Access Compliance Report Public Rights-of-Way (Curb Ramps)

Intersection ID: 16682 Main Street: MARSH RD **Cross Street: LEASIDE LN** Location: Ε ADA ID: 4B4C4473358D Ramp Type: PerpDiag Initial Pass/Fail: Fail **Overall Compliance: No Severity Score:** 50

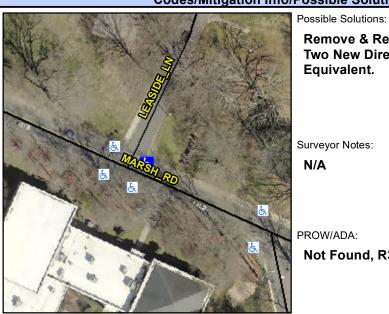
Not Found, R304.2.2, R304.5.3

Field Measurements/Component Compnance					
Compliance Description		Data	Compliance Description		Data
N/A	Ramp Length (in)	60.0	No	Ramp Slope (%)	18.8
Yes	Ramp Width (in)	48.0	No	Ramp XSlope (%)	8.1
N/A	Flare Type LT	N/A	N/A	Flare Type RT	N/A
N/A	Flare Slope LT (%)	N/A	N/A	Flare Slope RT (%)	N/A
N/A	Flare Traversable LT?	N/A	N/A	Flare Traversable RT?	N/A
N/A	Landing Length (in)	N/A	N/A	DWS Provided?	N/A
N/A	Landing Width (in)	N/A	N/A	DWS Contrast?	N/A
N/A	Landing Slope (%)	N/A	N/A	DWS Length (in)	N/A
N/A	Landing X Slope (%)	N/A	N/A	DWS Full Width?	N/A
N/A	Landing Curb? (Y/N)	N/A	N/A	DWS Offset (in)	N/A
N/A	Shared Landing?	N/A			
N/A	Gutter Ponding?	N/A	N/A	Gutter Slope (%)	N/A
N/A	Gutter Lip Ht (in)	N/A	N/A	Gutter X Slope (%)	N/A
N/A	Painted X Walk1?	No	N/A	Painted X Walk2?	No
	X Walk 1 Direction	To NW		X Walk 2 Direction	To SW
N/A	X Walk 1 Width (in)	N/A	N/A	X Walk 2 Width (in)	N/A
	X Walk 1 Slope (%)	6.4		X Walk 2 Slope (%)	3.0

Remove & Replace Curb Ramp With **Two New Directional Ramps or** Equivalent.
